Planning Commission Staff Report

Project type: Sign Package

Location: 1772 Clarkson Road

Description: **Dierbergs The Market Place (Billy G’s), Sign Package:** A sign package for Dierbergs The Market Place located on an 11.35-acre tract of land located east of Clarkson Road and north of Baxter Road, zoned “C8”- Planned Commercial District.

Figure 4: Sign Request

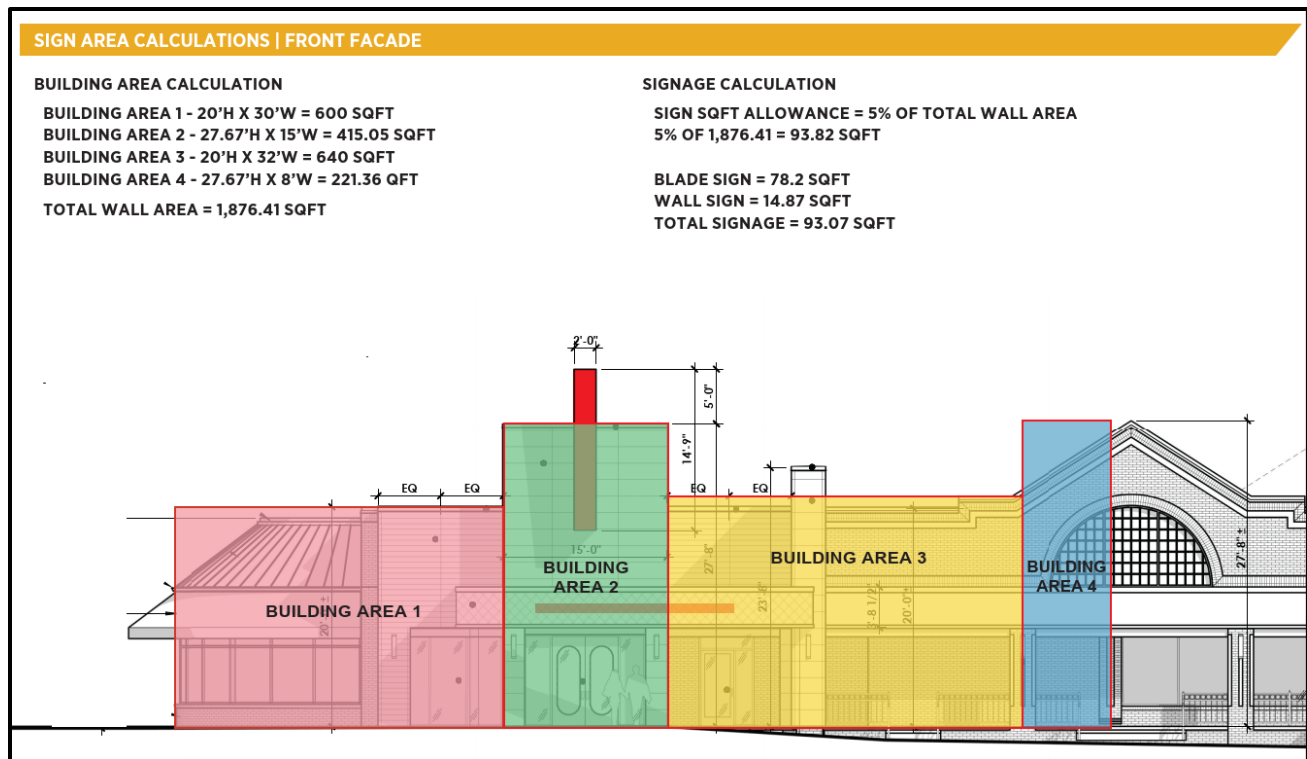
As per the Unified Development Code of the City of Chesterfield, blade signs are not permitted. In order to have a blade sign, the applicant has submitted a sign package. In 2021, the structure for the blade sign for the outlot building was approved as an architectural feature by the Planning Commission. At that time, the applicant was not proposing to use this as a blade sign. The applicant has now requested to amend the existing sign package of Dierbergs The Market Place to include one blade sign on the outlot building. As per the existing sign package for Dierbergs The Market Place, outlot buildings are allowed to have one attached wall sign per tenant space not to exceed 5% of the building elevation. The amended sign package will allow one blade sign and one attached wall sign only to the tenant space on the outlot building that will have the blade sign. The total area of the blade sign and the wall sign will not exceed 5% of the building elevation.

Exhibit A

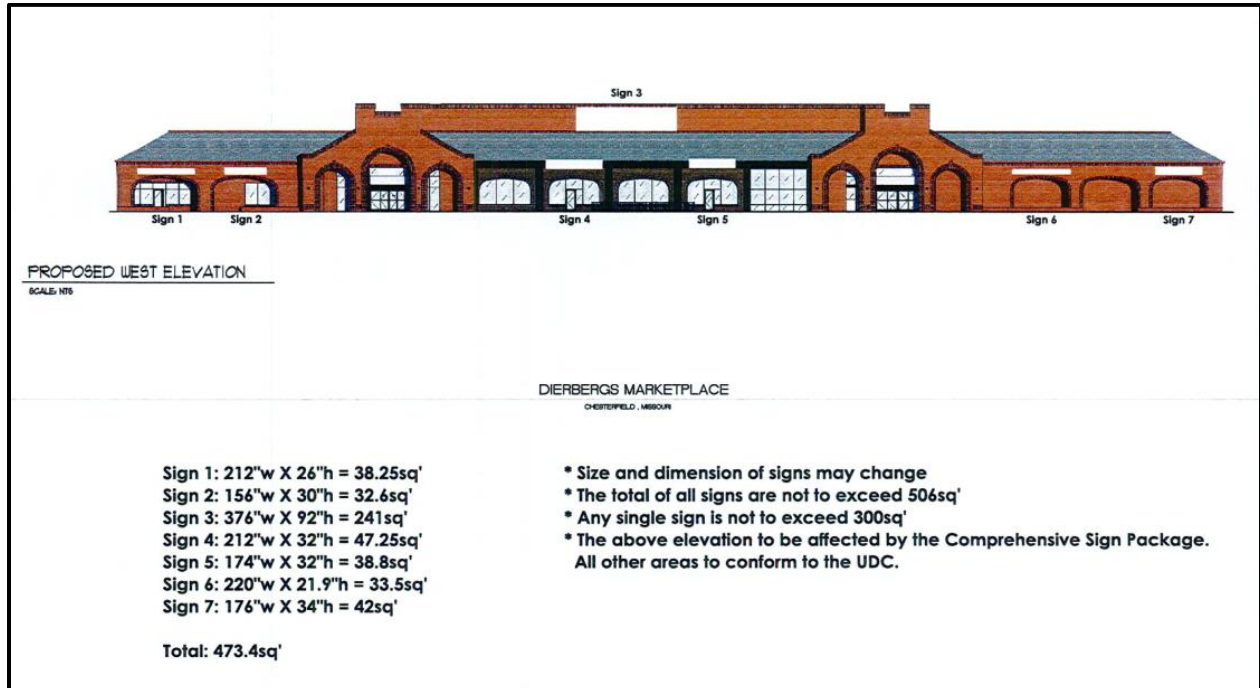
1. The building area as identified in Exhibit A is allowed to have 7 wall signs.
2. Total square feet of all signs is not to exceed 506 sq. ft.
3. Any single sign shall not be greater than 300 sq. ft.
4. Center signs, sign 4 and sign 5 as identified in Exhibit A, shall be attached to the frame instead of the entry area.

Exhibit B

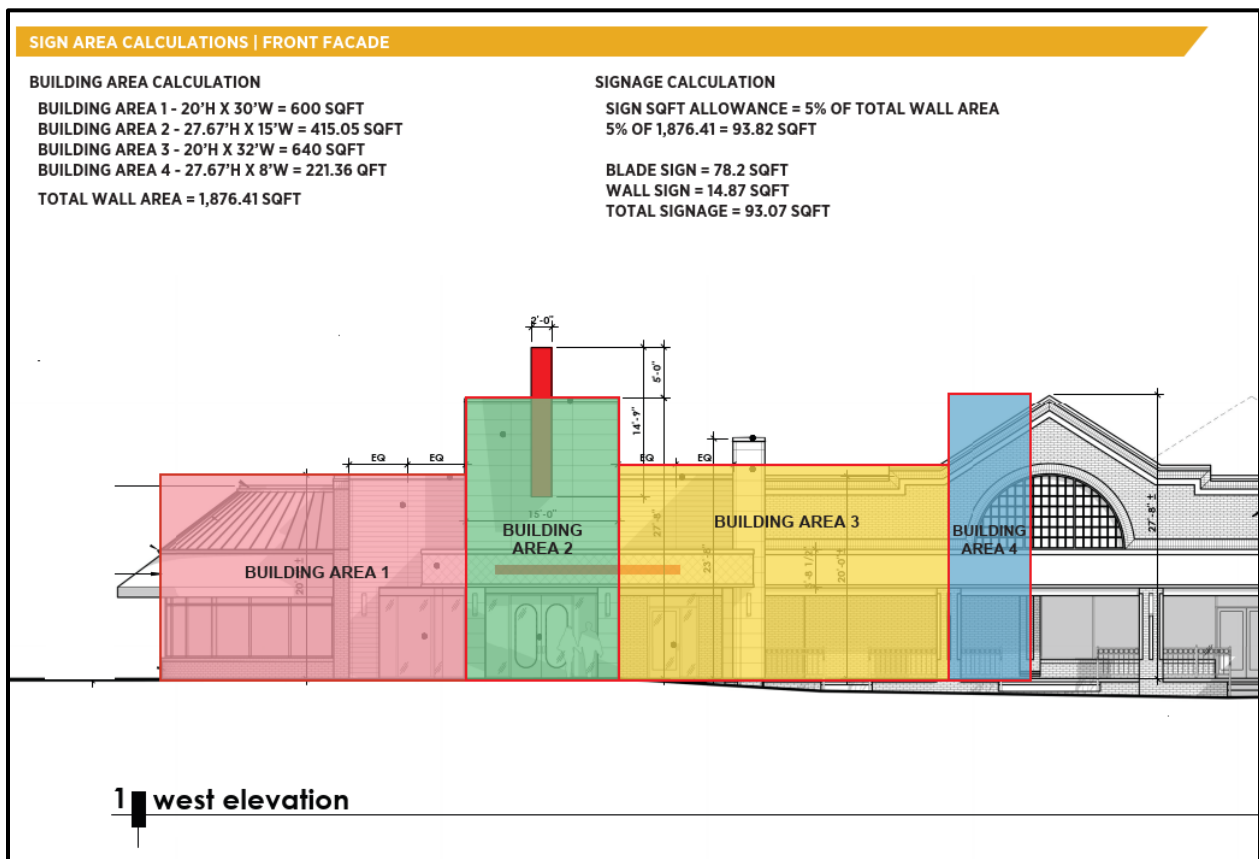
Northern tenant space as identified in Exhibit B

1. One Blade Sign permitted on west elevation.
2. One wall Sign permitted on west elevation.
3. Total sign area (Blade sign + Wall sign) shall not exceed 5% of building elevation.
